Gulf Power Company's
Quality Assurance
Process
for
Distribution
Construction

By Authority of The State of Florida Public Service Commission Division of Regulatory Compliance Bureau of Performance Analysis

August 2009

EXHIBIT 3 Source: DR-1.7c, DR-1.9c

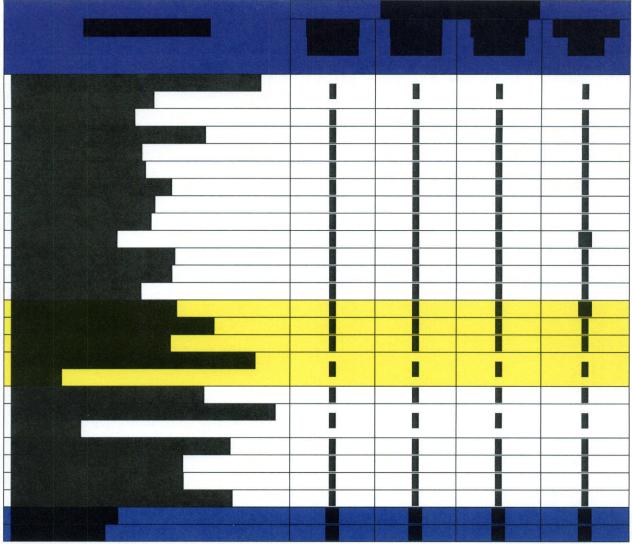
As Exhibit 3 shows,

during the 72 quality inspections performed in the period. FPSC audit staff notes that of these,

Gulf does not rank deficiencies by level of severity stating that if it were to rank deficiencies by severity, those ranked as minor could get less attention.

FPSC audit staff believes there is value in having a deficiency ranking system for all companies big and small because priority is to be given to variances that have the potential of exposing the public to a hazardous condition. Audit staff suggests that Gulf consider a ranking system.

Gulf does not derive significant benefit in ranking the severity of deficiencies since <u>all</u> deficiencies are addressed. Creating a multi-level ranking hierarchy will unnecessarily complicate an otherwise simple concept that Gulf believes is effective. Gulf concedes that separating NESC violations or safety deficiencies and non-NESC deficiencies is a good concept and agrees to implement language in its process that requires Gulf to document the dates in which NESC/Safety deficiencies are corrected and reviewed by a follow-up inspection. Gulf will correct non-NESC violations as it currently does but does not propose to document the actions taken with respect to the non-NESC deficiencies.
